UNITED STATES ENVIRONMENTAL PROTECTION AGENCY  
REGION IX  
75 Hawthorne Street  
San Francisco, CA 94105

RE: December 17, 2003 Site Visit Summary and Phased Approach to Evaluating Technically Enhanced Naturally Occurring Radionuclides (TENORM) at the Anaconda Copper Mine Site, Yerington, Nevada

**ANACONDA COPPER MINE SITE - YERINGTON, NEVADA  
SEMI-QUANTITATIVE GAMMA RAY WALKOVER SURVEY OF UNLINED EVAPORATION PONDS  
NOS. 1 AND 1A**

# EXPLORANIUM GR130 Spectrum Data

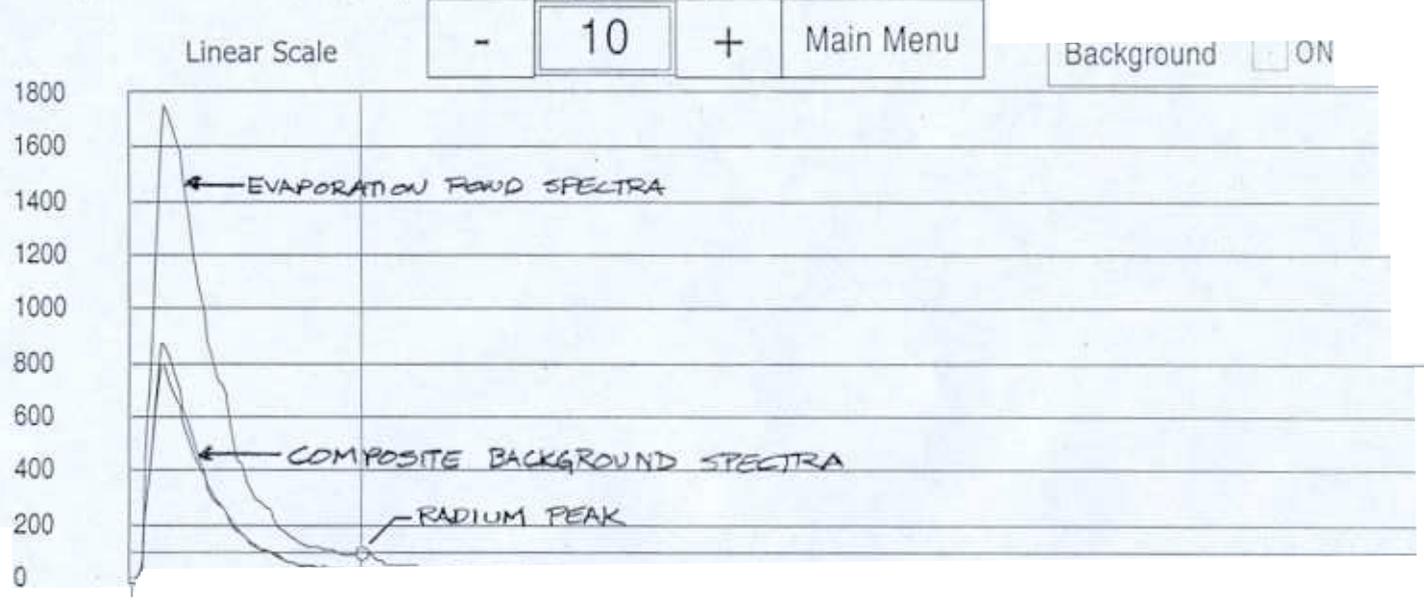
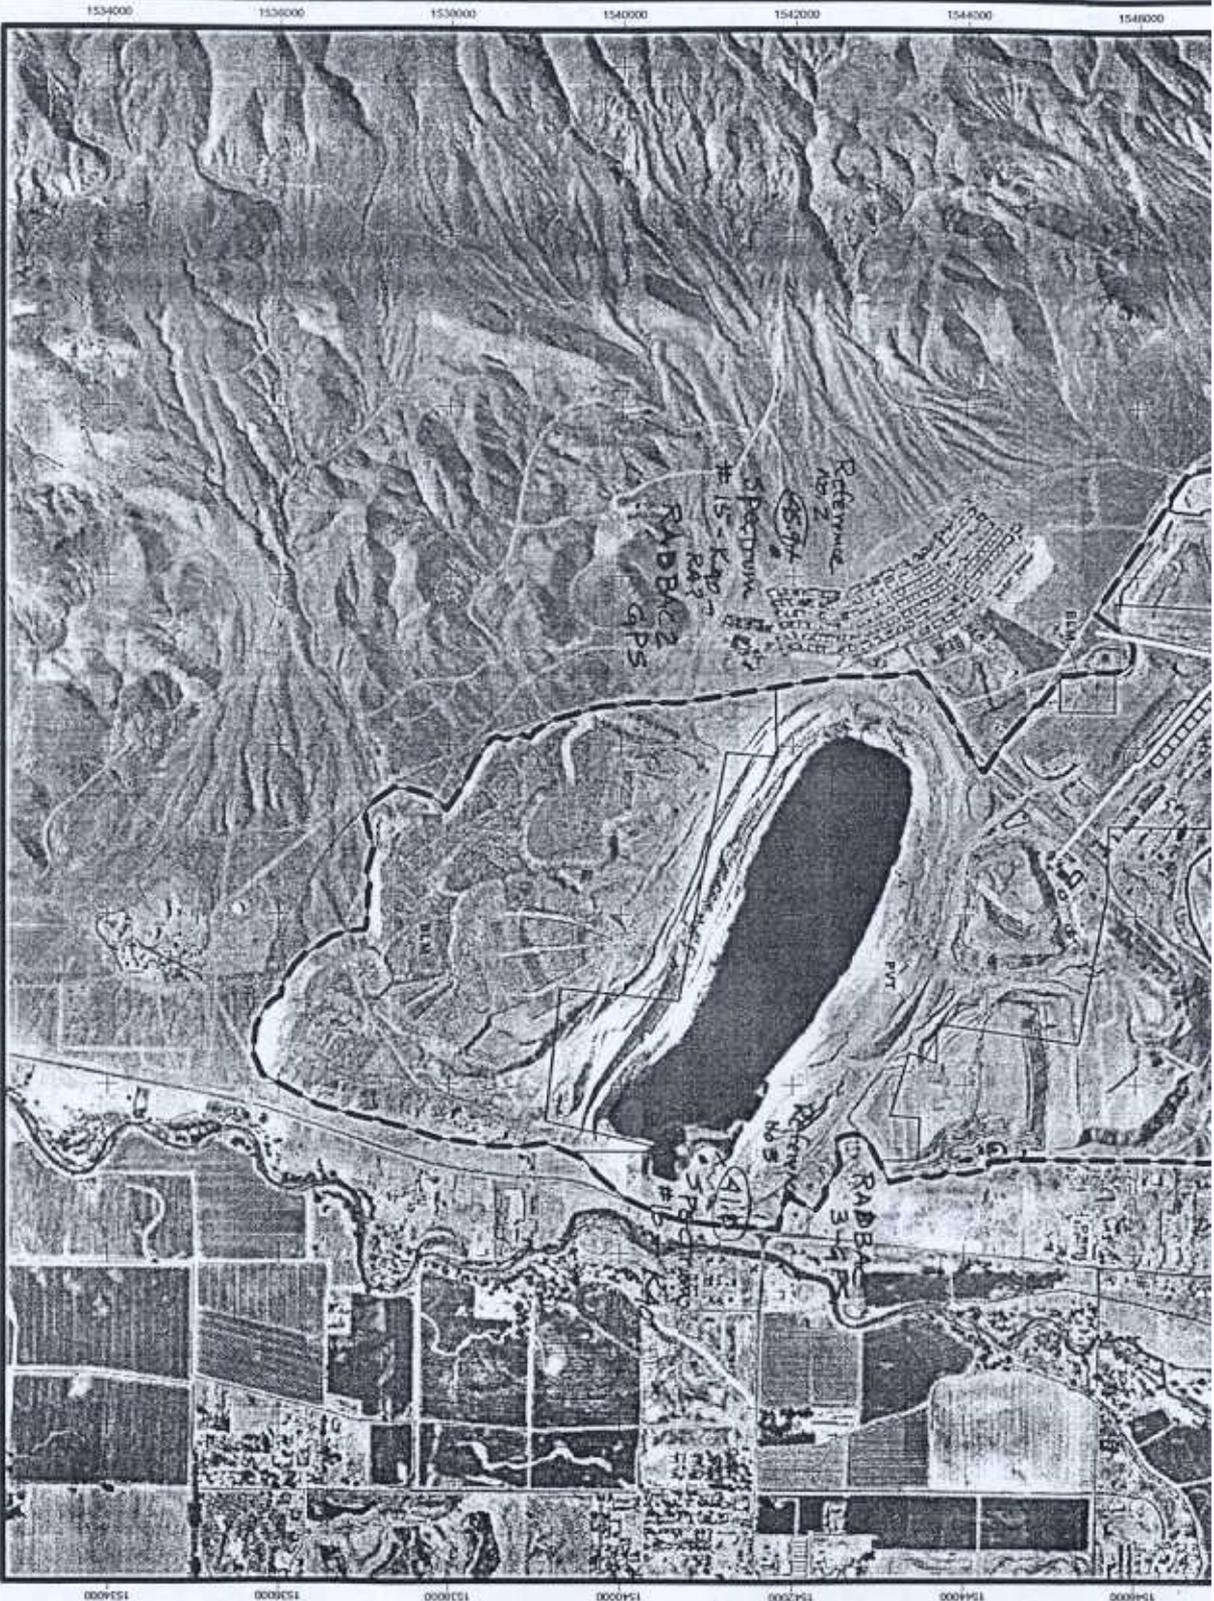
- § The gamma ray spectra for the three potential reference locations correlate reasonably well over three different geologic locales (see attached spectra) .

- § The anomalous areas in Pond 1 exhibit values of up to 2X background on gross gamma counts, while comparison of the gamma spectra from the three reference locations indicates up to 3X background for radium, with additional anomalous areas of thorium and potassium 40.
